South Texas Project  
Units 3 and 4  
Docket Nos. 52-012 and 52-013  
Response to Requests for Additional Information

Attached are responses to NRC staff questions included in Request for Additional Information (RAI) letter number 377 related to Combined License Application (COLA) Part 2, Tier 2, Section 9.1, "Fuel Storage and Handling." This letter responds in part to RAI letter number 377 for the specific RAIs listed below. Additional responses will be provided on August 5 and September 15, 2011, to complete the response to letter 377. In addition it should be noted that the RAIs in letter 377 related to new fuel racks have been answered by reference to a pending departure deleting the installation and use of new fuel racks. This departure is consistent with the STP Nuclear Operating Company's Unit 1 & 2 practice of storing new fuel in the spent fuel racks. NINA intends to incorporate this departure into Revision 6 of the STP 3 & 4 COLA.

**RAI 09.01.02-2****QUESTION:**

Summary: Provide more descriptive information on pools, racks and fuel-handling system.

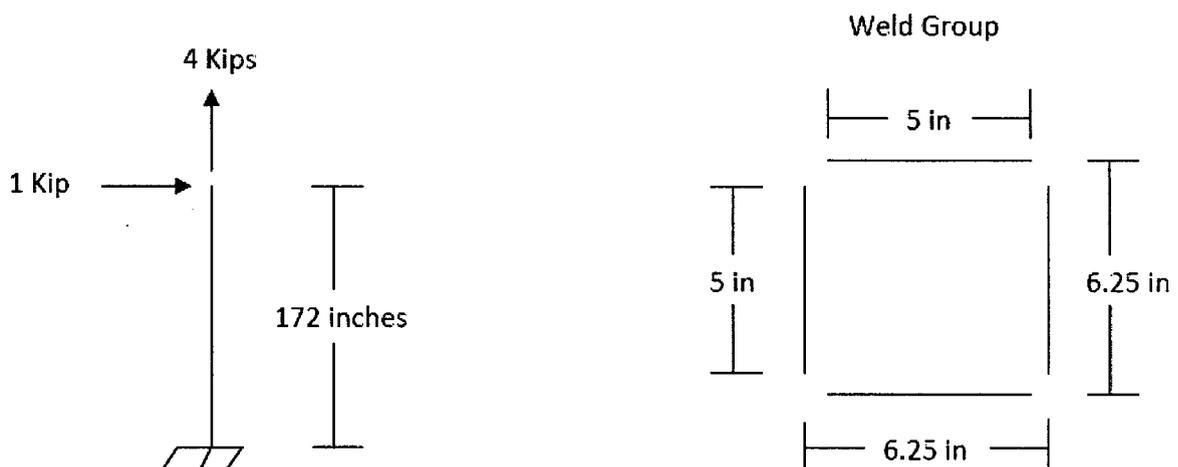
- b. Provide values for  $T_o$  and  $T_a$ . According to Appendix D to SRP 3.8.4, for the load combination with SSE, the temperature  $T_a$ , which is defined as the highest temperature associated with the postulated abnormal design conditions, should be assumed. Explain why material properties at 140 °F were used for the spent fuel rack design evaluation for the load combination with SSE.

maximum accident temperature of 212°F. Material properties used in the SSE load combinations will be taken at 212°F. The updated analysis will be incorporated into the revised WCAP to be submitted by September 15, 2011.

Figure 1 Comparison of Input vs. Calculated Response Spectra, Horizontal (X)

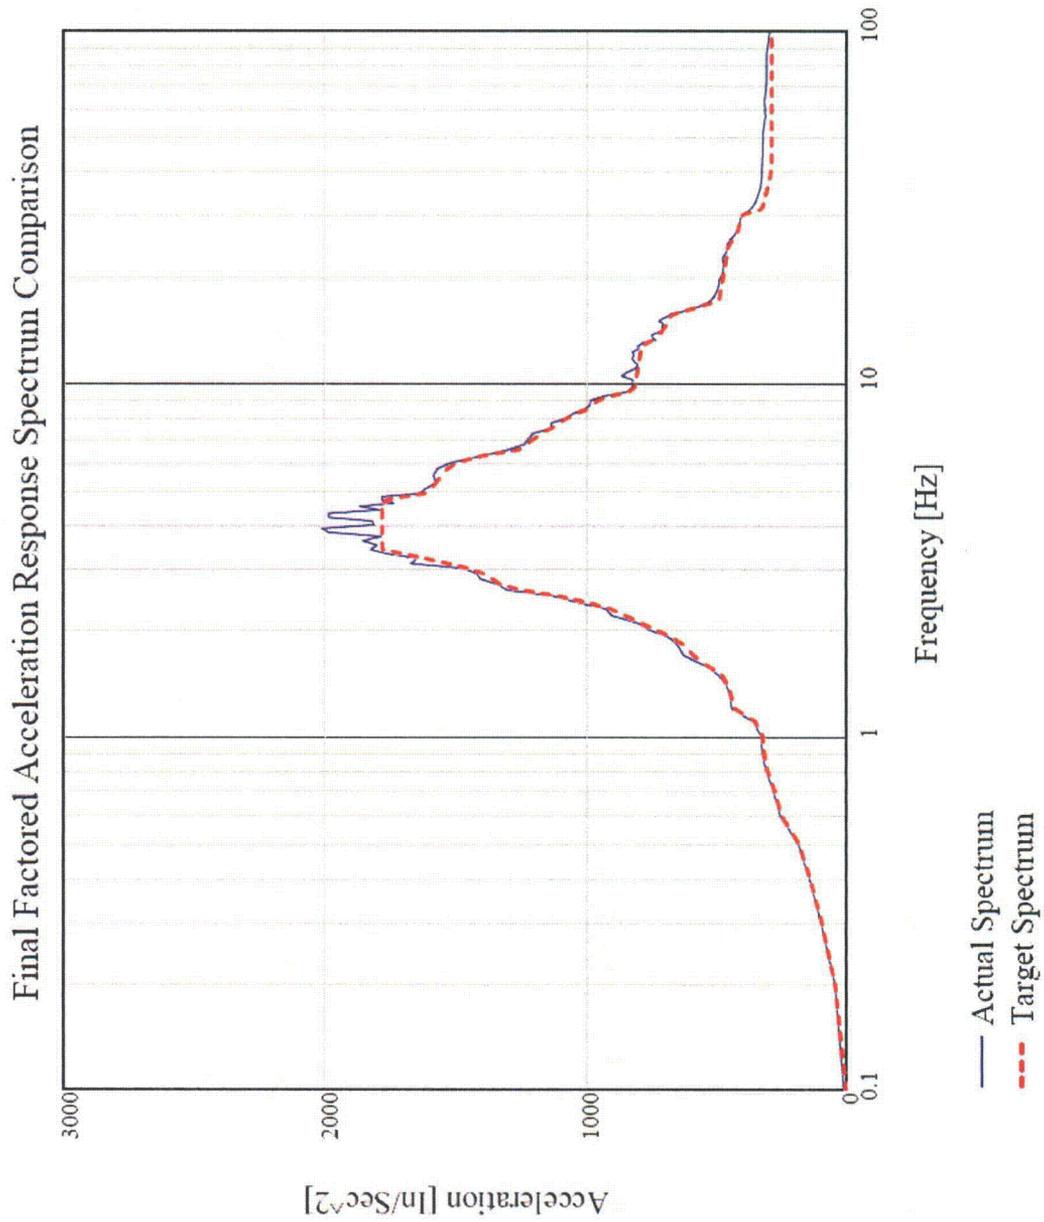
- a. Confirm that the 3 synthetic time histories have been checked against each other to ensure statistical independence. Compare the calculated correlation coefficients to the acceptance criterion of  $\leq 0.16$ . Include this information in the spent fuel racks technical report.
- b. Provide figures comparing the 5% damped spectra (2 horizontal, vertical) generated from the synthetic time histories to the 5% damped target spectra (horizontal, vertical) at node 100. Identify the criteria used to verify the adequacy of the match. Include this information in the spent fuel racks technical report.

- b. Synthetic time histories were created for 4% damping at Node 100, per the requirements of Reg Guide 1.61, "Damping Values For Seismic Design Of Nuclear Power Plants," as required for welded steel or bolted steel structural material with friction connections (Table 1), not the 5% as requested above.

The following table shows compliance to the NUREG-0800, Standard Review Plan Section 3.7.1 for Response Spectra Comparison (the number of points below the target is less than or equal to 5, and the maximum percent under the target is less than 10%):

The following Figures 1, 2, and 3 show that the synthetic generated time histories envelope the target response spectra using 4% damping at Node 100 for all three directions. This information will be included in the spent fuel racks Technical Report.

Figure 4 Actual Raw and Average PSD vs. Target – Horizontal (X)

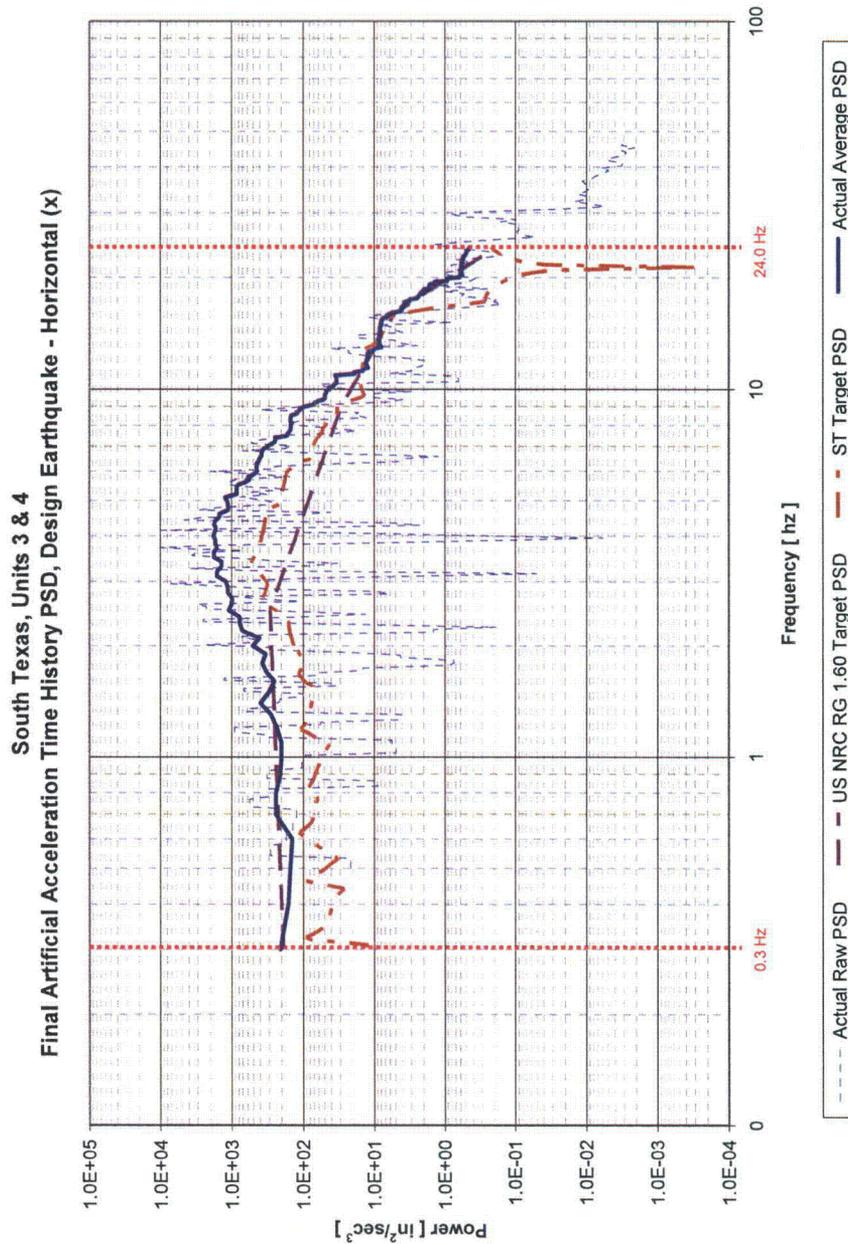
- c. Describe how target PSDs were developed for the Node 100 target spectra, and provide figures comparing the PSDs for the synthetic time histories to the PSDs for the target spectra. Identify the criteria used to verify the adequacy of the PSDs for the synthetic time histories.

To develop a site-specific target PSD, the Westinghouse-computer code PowerSpec version 2.0.2, Module 2 was used to generate a PSD from the STP-specific Design Basis Response Spectra (DBRS) at 4% damping. The resulting calculated target horizontal and vertical PSDs was used for comparison to the actual average PSD generated from the artificial time histories.

The PSD check that is required by SRP Section 3.7.1 is for synthetic motion generated at the ground level. Since our synthetic motion is at a higher elevation within containment, we have conservatively applied the PSD check at our higher elevation. There are two small frequency ranges (between 0.3-0.4 Hz in the horizontal "Y" direction and between 10-20 Hz in the horizontal "X" direction) where the actual PSD is below the site specific target PSD. The
